Access Compliance Report

Public Rights-of-Way

(Curb Ramps)

Intersection ID: 24473	Main Street: CAMERON_WOOD_DR	Cross Street: DEER SPRING_LN	Location: W
ADA ID: 16B015EEC4A3	Ramp Type: PerpDiag	Initial Pass/Fail: Fail	Overall Compliance: No
Severity Score: 33.75			
Codes/Mitigation Info/Possible Solution		Field Measurements/Component Compliance

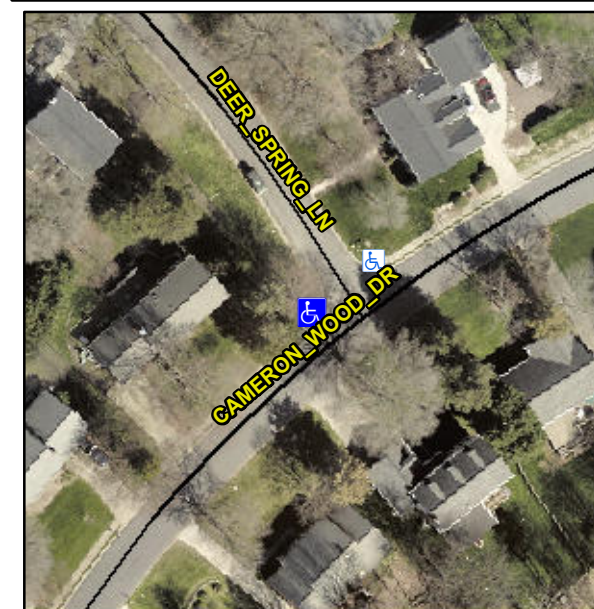
Not Found, R304.5.1, R304.2.2, R304.5.3

Compliance	Description	Data	Compliance	Description	Data
N/A	Ramp Length (in)	60.0	No	Ramp Slope (%)	9.3
No	Ramp Width (in)	39.0	No	Ramp XSlope (%)	6.0
N/A	Flare Type LT	N/A	N/A	Flare Type RT	N/A
N/A	Flare Slope LT (%)	N/A	N/A	Flare Slope RT (%)	N/A
N/A	Flare Traversable LT?	N/A	N/A	Flare Traversable RT?	N/A
N/A	Landing Length (in)	N/A	N/A	DWS Provided?	N/A
N/A	Landing Width (in)	N/A	N/A	DWS Contrast?	N/A
N/A	Landing Slope (%)	N/A	N/A	DWS Length (in)	N/A
N/A	Landing X Slope (%)	N/A	N/A	DWS Full Width?	N/A
N/A	Landing Curb? (Y/N)	N/A	N/A	DWS Offset (in)	N/A
N/A	Shared Landing?	N/A			
N/A	Gutter Ponding?	N/A	N/A	Gutter Slope (%)	N/A
N/A	Gutter Lip Ht (in)	N/A	N/A	Gutter X Slope (%)	N/A
N/A	Painted X Walk1?	No	N/A	Painted X Walk2?	No
	X Walk 1 Direction	To S		X Walk 2 Direction	To NE
N/A	X Walk 1 Width (in)	N/A	N/A	X Walk 2 Width (in)	N/A
	X Walk 1 Slope (%)	3.5		X Walk 2 Slope (%)	7.4
	X Walk 1 X Slope (%)	6.6		X Walk 2 X Slope (%)	2.5

Remove & Replace Curb Ramp With Two New Directional Ramps or Equivalent.
